RECEIVED
CK'D BY LWSS OK'D BY RSF
SEP 04 2002
RESUBMIT ____ APPROVED
BY QPW DATE 9/17/02

DESCRIPTION:	CROSSFRAME LAYOUTS	DRAWN BY	DATE
JOB:	US Route 5 over Northern Vermont RR	WL	08/01
	BRIDGE NO. 161	CHKD BY	
	BARTON, VERMONT (ORLEANS COUNTY)	JAK	08/05
TENSOR 2256	CONTRACTOR: WINTERSET	APPROV BY	
		SUPERVISOR	W. J. GATTI
PROJ NO.	AC STP 0113 (58) S	Q.A.	
CUSTOMER:	VERMONT AGENCY OF TRANSPORTATION

TYP. END CROSSFRAME

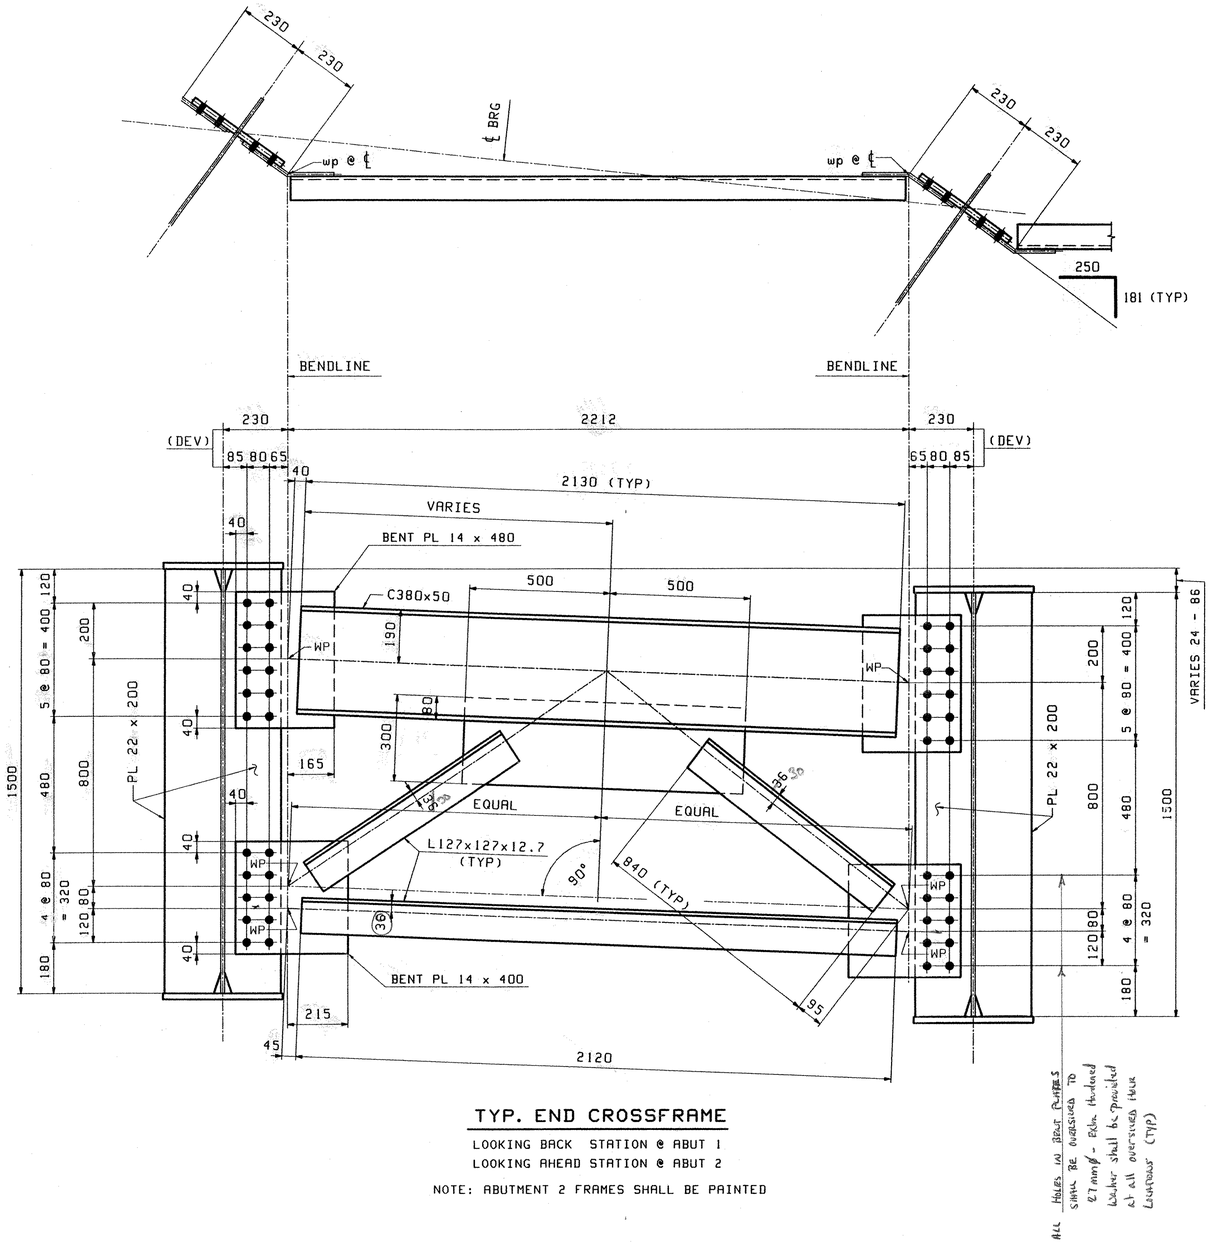
NOTE: ABUTMENT 2 FRAMES SHALL BE PAINTED

All holes in bent plates shall be oversized to 27 mm ø. Bolts tightened under shall be specified at all oversized holes (TYP)
